HIGH ALTITUDE CARBURETOR KITS/1978 1/2 AND 1979 MODELS

HIGH ALTITUDE CARBURETOR KIT $1978\frac{1}{2}$ & LATER 1200/1340cc AND 1979 & LATER 1000cc MODELS

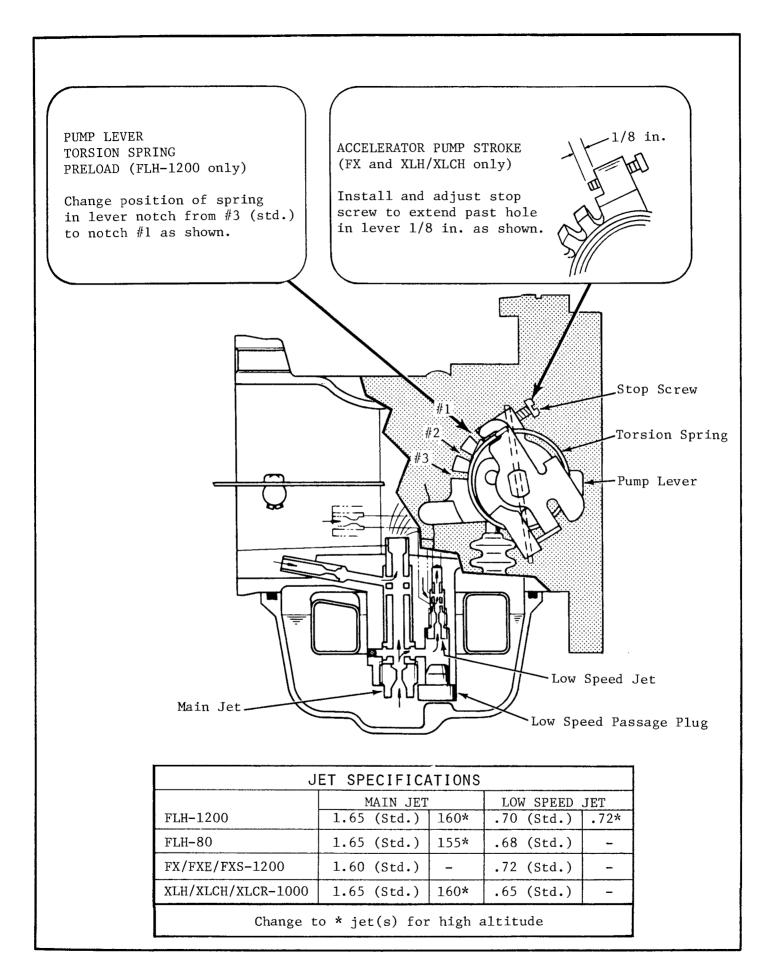
FLH, XLH, XLCH and XLCR models require jet changes as specified in above table. Jet changes can be made with carburetor assembled to engine. Remove float chamber to make jet changes by removing 3 short screws and 1 long screw from bottom of carburetor. See illustration for location of main jet and low speed jet with cover plug. When removing chamber, note position of accelerator pump rod for correct reassembly. Unscrew old jets and install correct jets in applicable carburetor as shown in table.

FX, FXE, FXS, XLH, XLCH and XLCR models require installation of accelerator pump stop screw, part number 27306-76, to reduce the pump stroke. A right angle Phillips tip screwdriver facilitates installation of the screw with carburetor assembled to the engine. A right angle screwdriver can be obtained locally or made by heating a screwdriver tip to red hot using a torch, clamping the hot screwdriver tip into a vise about 3/4 in. and bending to a 90° angle. Turn the self-tapping screw into the blank hole of the accelerator pump lever as shown in the illustration. Threaded tip of screw should extend out of the lever hole 1/8 in. as shown.

On the FLH-1200 model only, change preload position of the pump lever torsion spring from notch #3 (standard) to notch #1.

KIT PART NO.	MODEL	ITEM
27094-78	FLH-1200	No. 160 Main Jet No. 72 Low Speed Jet Label for Frame Front Down Tube
27095–78	FX/FXE/FXS-1200	Accelerator Pump Stop Screw Label for Frame Front Down Tube
27096–79	XLH/XLCH/XLCR-1000	No. 160 Main Jet Accelerator Pump Stop Screw Label for Frame Front Down Tube
27093-78	FLH-80 (1340cc)	No. 155 Main Jet Label for Frame Front Down Tube
